Town Planning Application No. A/YL-NSW/348 - Submission of Further Information (1)

**Proposed Social Welfare Facility (Residential Care Home For Persons With Disabilities) In “Village Type Development” Zone on Approved Nam Sang Wai Outline Zoning Plan No. S/YL-NSW/10 at Lots 3669 S.A RP (Part), 3669 S.B RP (Part), 3670 RP (Part) and adjoining government land in D.D.104, Nam Sang Wai, Yuen Long
(Planning Application No. A/YL-NSW/348)**

Departmental Comments	Response
<u>Email dated 27th June 2025 refers: Social Welfare Department</u>	
1. Please advise to state clearly targeted services of its proposed RCHDs to be operated;	Regarding the targeted services of the proposed RCHD, it is intended to offer comprehensive care for both physically and mentally handicapped individuals, with a flexible range of services to address their diverse needs. The facility of the proposed RCHD will be operated in accordance with the standards of high-level nursing care services, and its design has been developed with this objective in mind to ensure optimal service delivery.

FIGURE 2.1

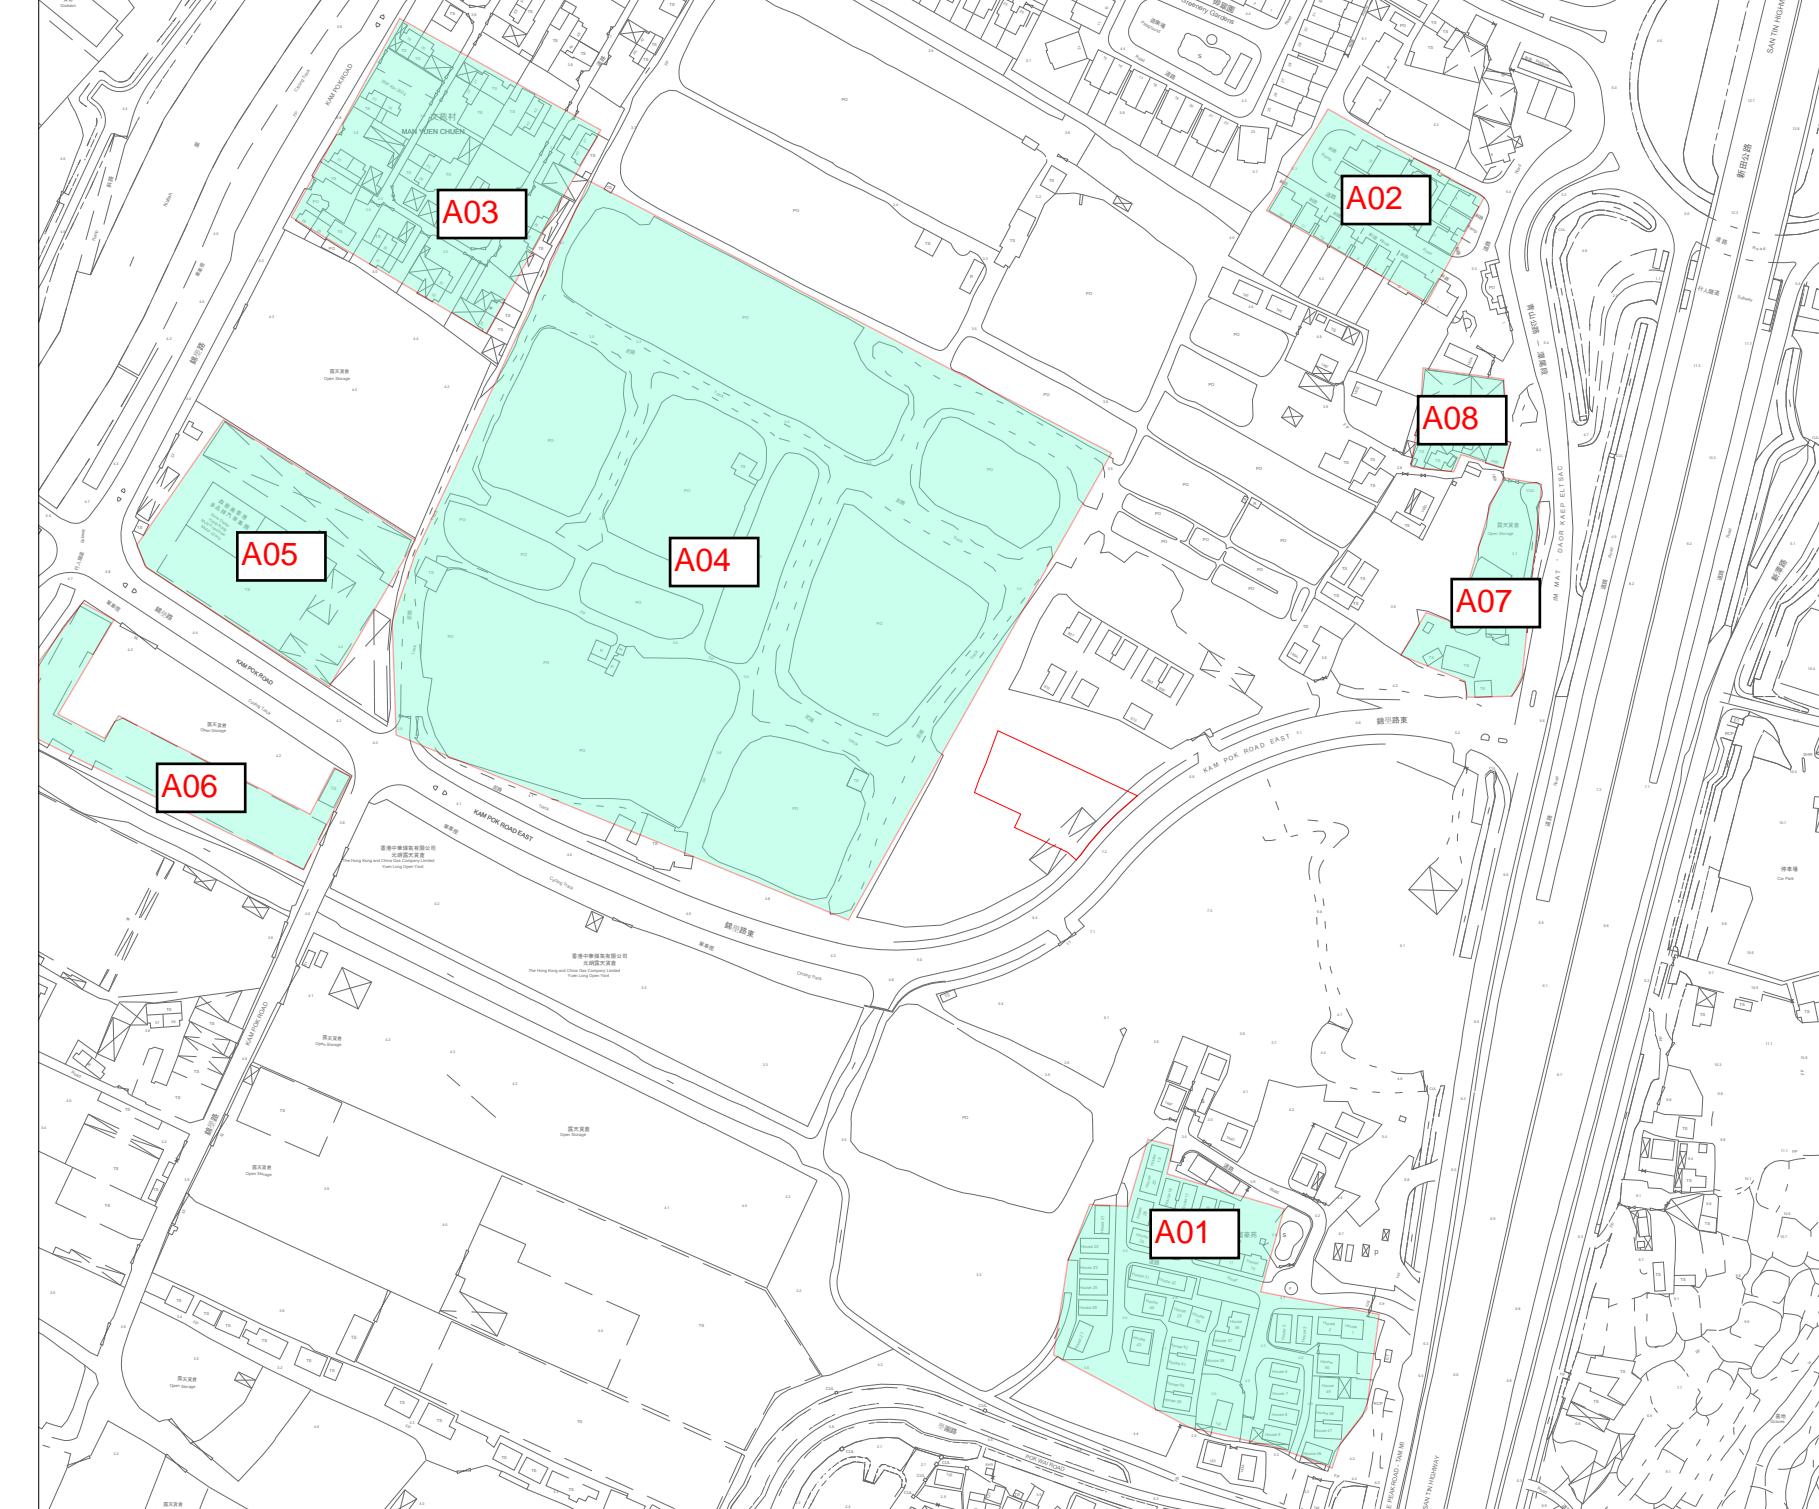
3. Section 2.3.1, Table 2.3 and Figure 2.1 - Please note that not only the domestic premises are the ASRs, some places/premises such as factory and workshop may also be the ASRs. Based on the desktop review, there are some areas in the vicinity of the project site which have been used for workshops/open storage, etc. Please review the potential existing/planned ASRs within the assessment area with reference to the Determination of ASR under the EIAO-TM and update as appropriate.	More ASRs have been identified in Table 2.3 and Figure 2.1. For other areas mainly for open storage use where long duration of exposure to air pollutants is not expected are, therefore, not considered as ASR.

**FIGURE 2.2
BUFFER DISTANCES**

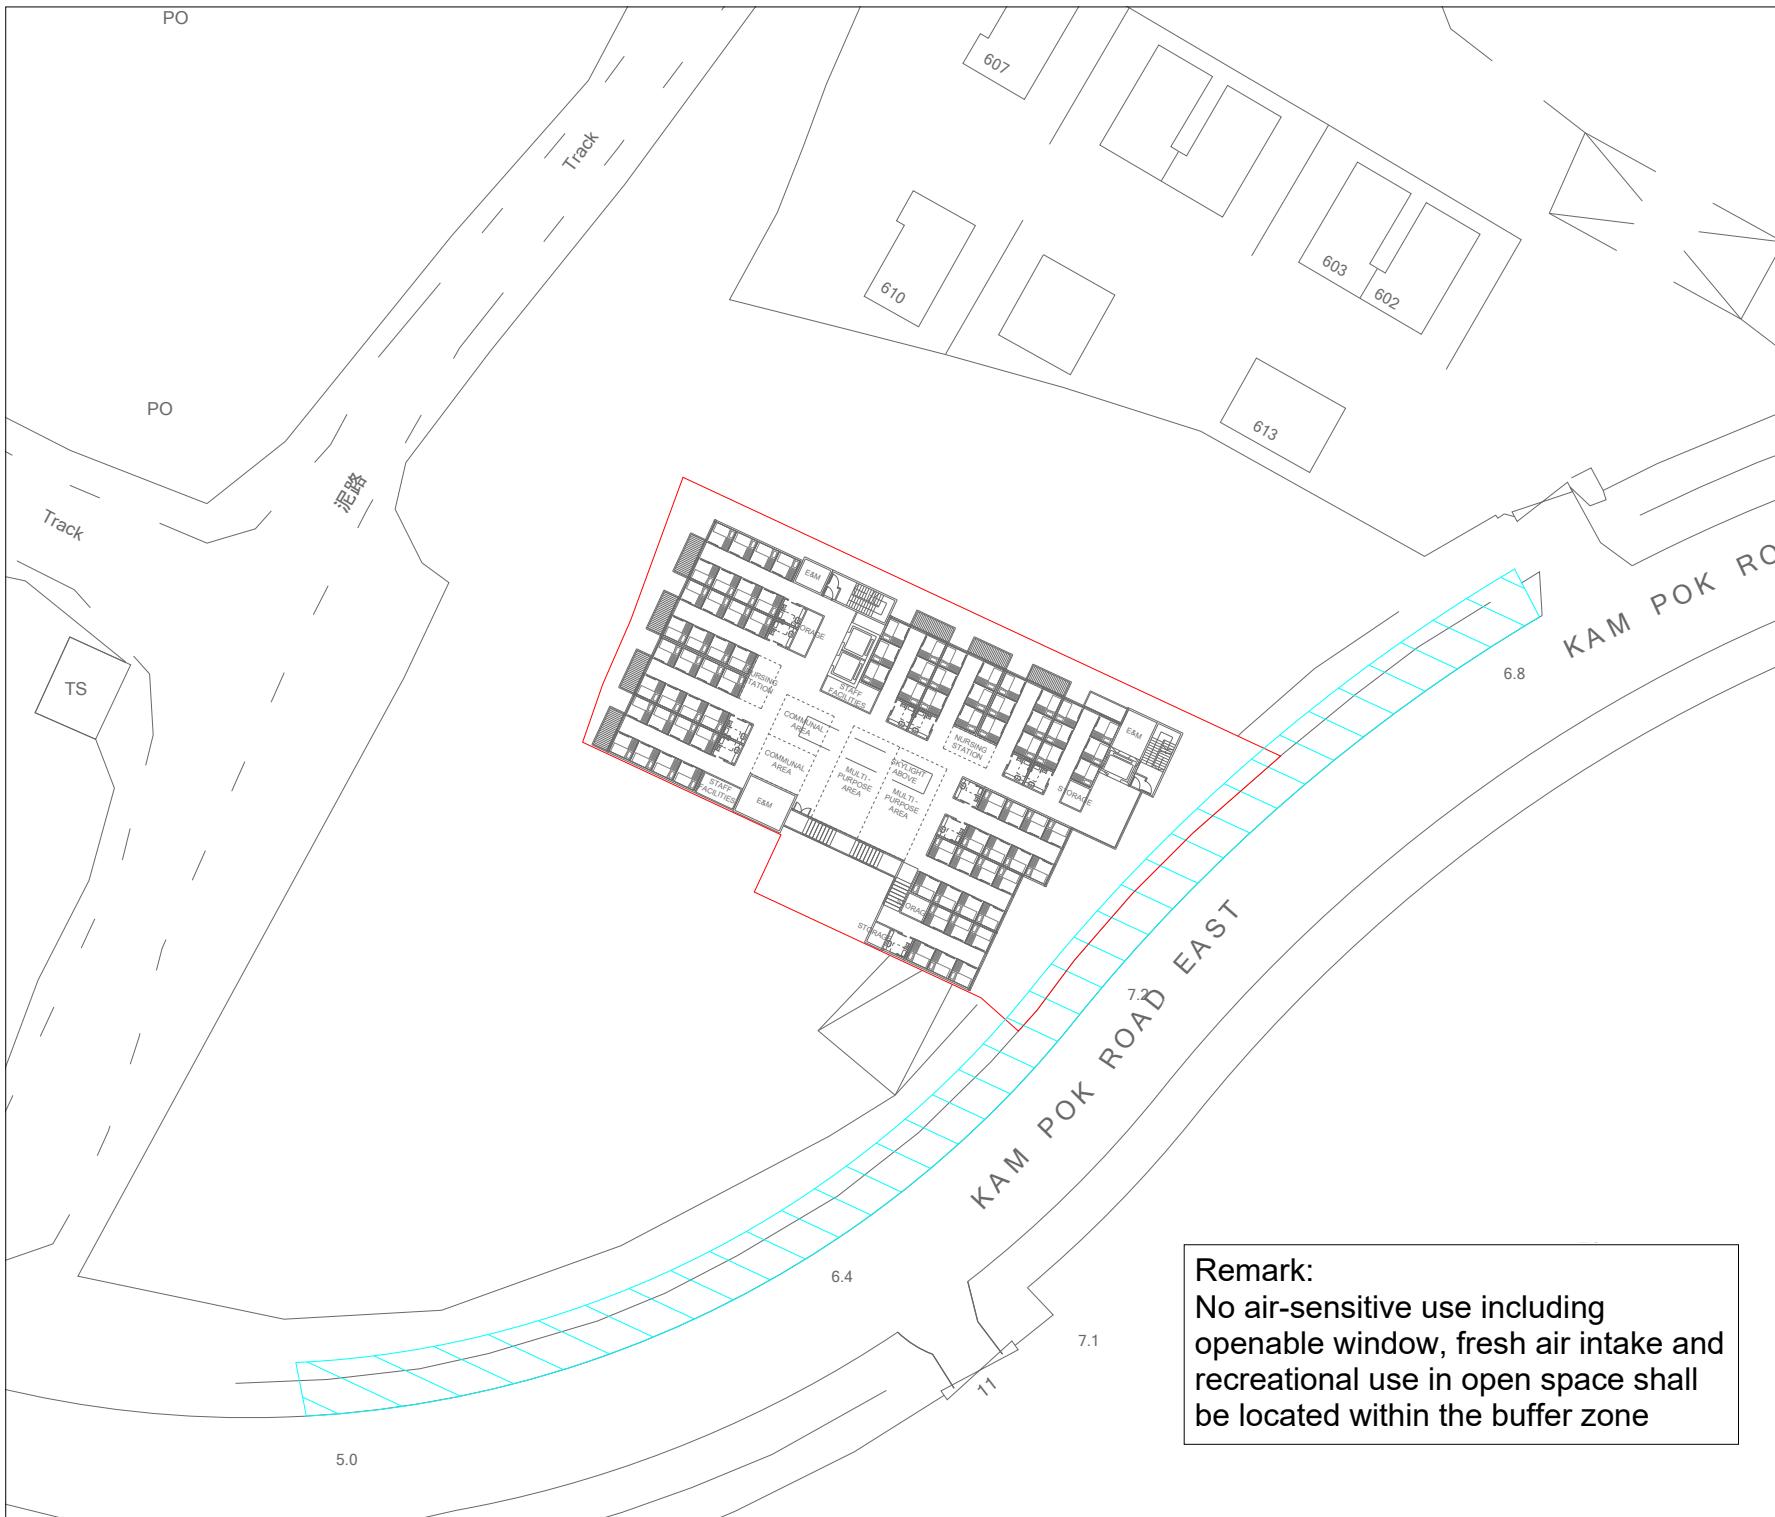
<p>12. Figure 2.2</p> <p>a. The buffer distance should be measured from the edge of road kerb. Please update and present the buffer zone appropriately.</p> <p>b. Please show the road name of Kam Pok Road East clearly in the figure.</p> <p>c. Please add a remark "No air-sensitive use including openable window, fresh air intake and recreational use in open space shall be located within the buffer zone".</p>	<p>Figure 2.2 is revised accordingly.</p>
<p>Sewerage (Please refer to Appendix 2 for the revised SIA)</p>	
<p>1. Section 2.2.2 - Please supplement with information of the public sewerage system identified along Kam Pok Road East e.g. alignment, pipe details etc. that is proposed to be utilized for discharging the sewage flow from the application site.</p>	<p>Section 2.2.2 is updated accordingly.</p>
<p>2. Appendix B – The hydraulic assessment should take into consideration the existing and planned developments utilizing the proposed sewerage network. Please revise.</p>	<p>Appendix B is updated accordingly.</p>

FIGURE 3

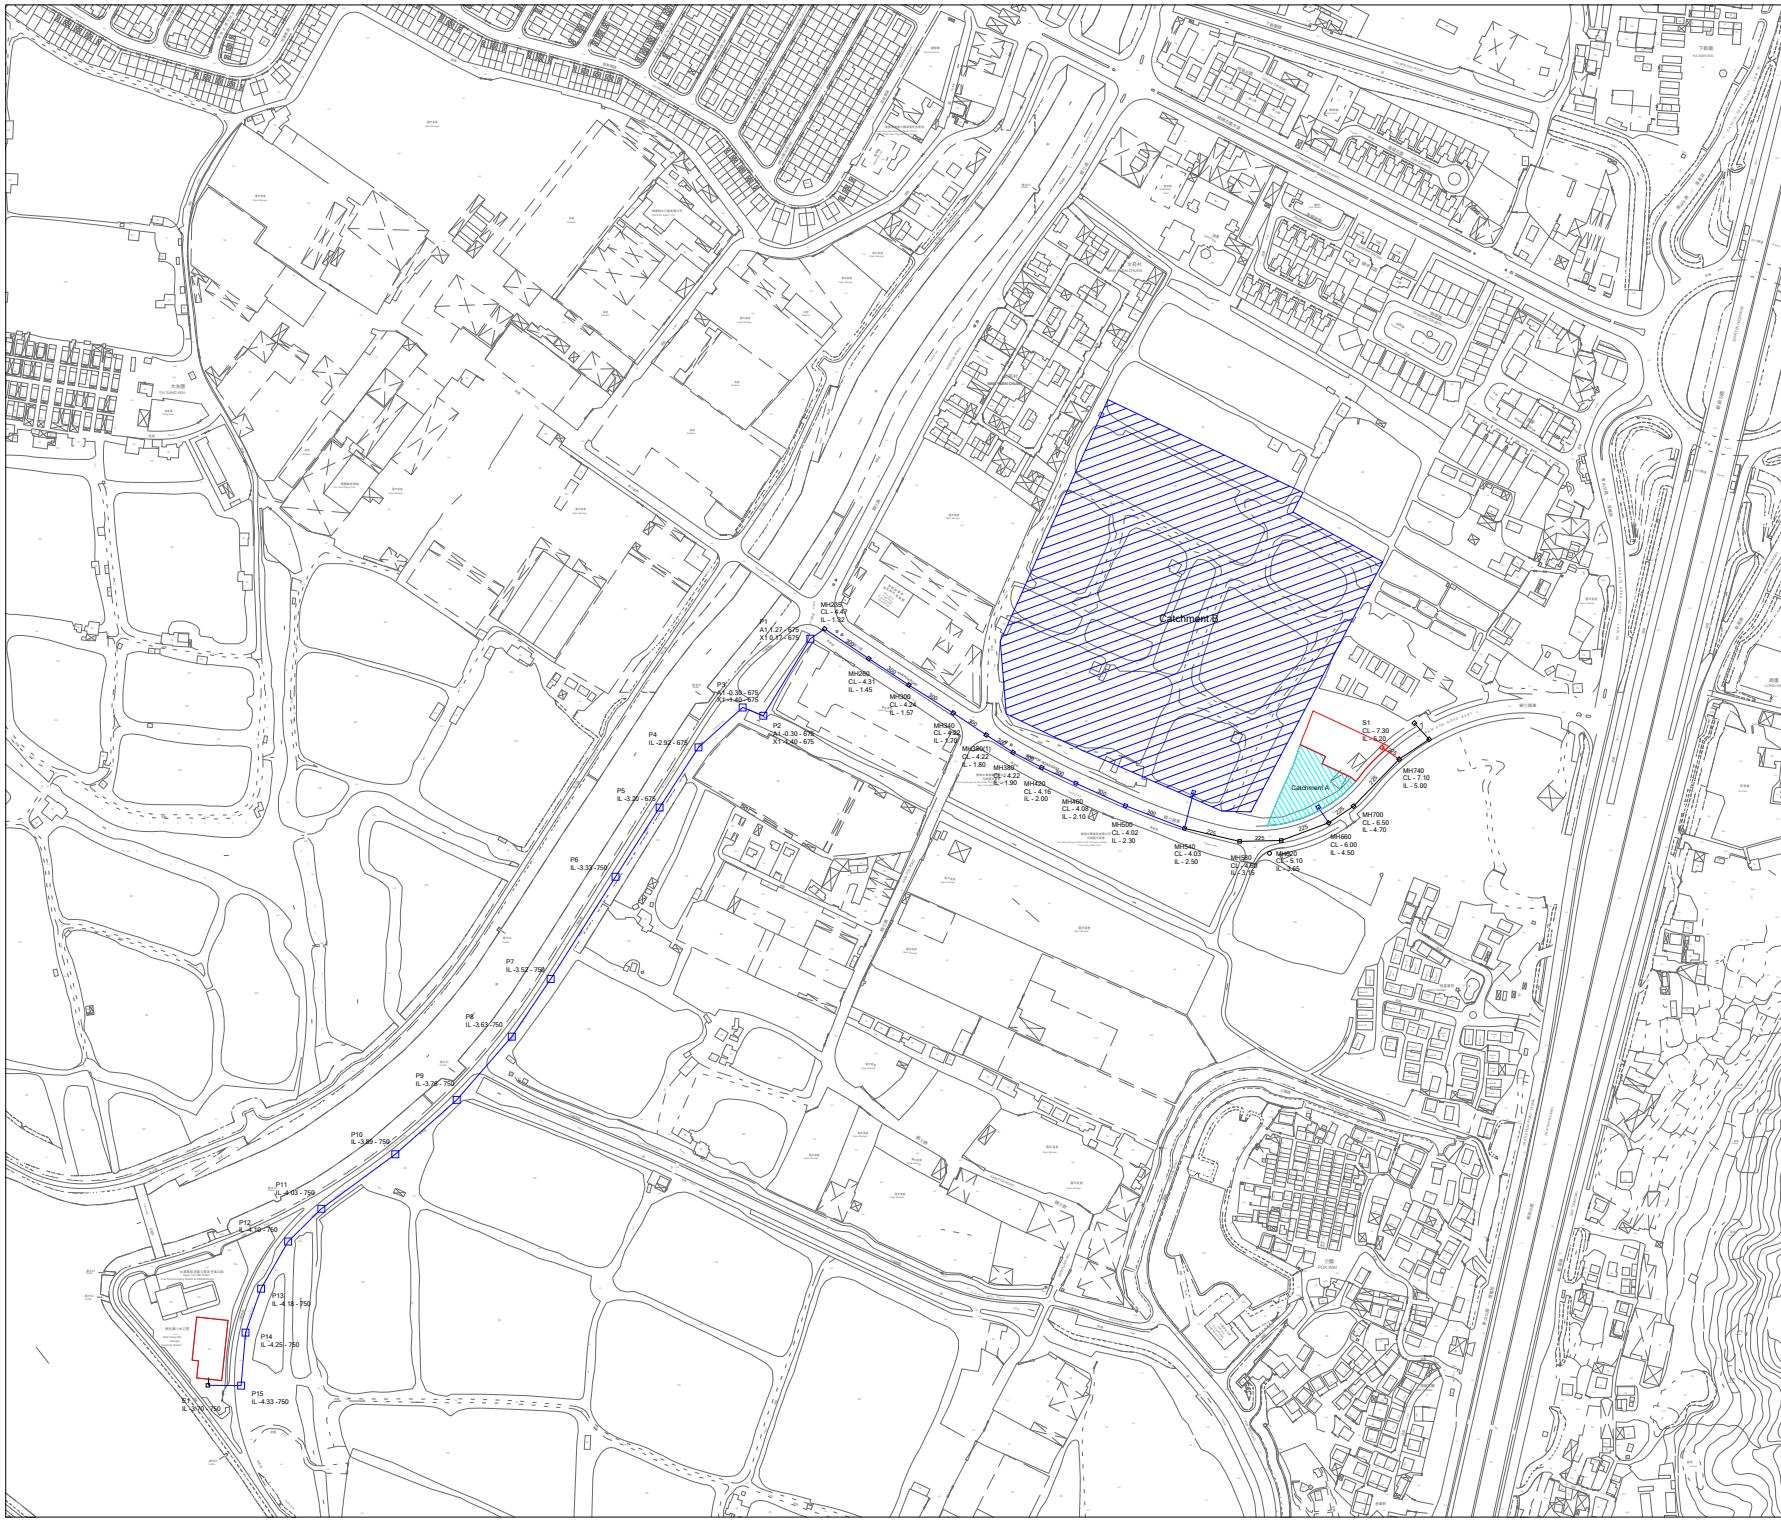
<p>3. Figure 3 – Please indicate the pipes and manholes to be provided under the application and by others.</p>	<p>Figure 3 is updated accordingly.</p>
<p>4. Please provide the population intake year.</p>	<p>The population intake year is provided in Section 1.3.1.</p>
<p>Email dated 4th July 2025 refers:</p>	
<p>Drainage Services Department (Comments on the SIA) (Please refer to Appendix 2 for the revised SIA)</p>	
<p>1. Para. 2.2.1 - Please check if the Figure 2 including existing sewerage record;</p>	<p>Figure 2 is supplemented.</p>
<p>2. Para. 2.2.2 - Please review "coube";</p>	<p>The typo is revised.</p>
<p>3. Para. 2.2.2 - Please review "termination" should read "terminal";</p>	<p>The typo is revised.</p>
<p>4. Para. 3.1.2 - Please clearly show the existing sewerage system on drawings for reference;</p>	<p>The existing sewerage system is indicated in Figure 3.</p>
<p>5. Please advise who will implement and maintain the proposed sewerage system/facilities. Please discuss in the report text and prepare a drawing for comment; and</p>	<p>Figure 3 is updated to include liability of implementation and maintenance. Detailed discussion refer to Para 2.2.2 and 2.2.3.</p>

<p>6. Figure 3 - Please indicate all cover levels. Please note that the cover level(s) of terminal manhole(s) should be higher than that of the downstream public manhole(s). Please include the above in report text and drawing remark.</p>	<p>The cover levels has included in Figure 3. Report text is provided in Para.2.2.3.</p>
<p>Email dated 27th June 2025 refers:</p>	
<p>Architectural Services Department</p>	
<p>Please provide photomontages of the proposal in its surrounding context from different vantage points.</p>	<p>The proposal in its surrounding context could be seen from 2 different vantage points as demonstrated by the photomontages attached in Appendix 3.</p>
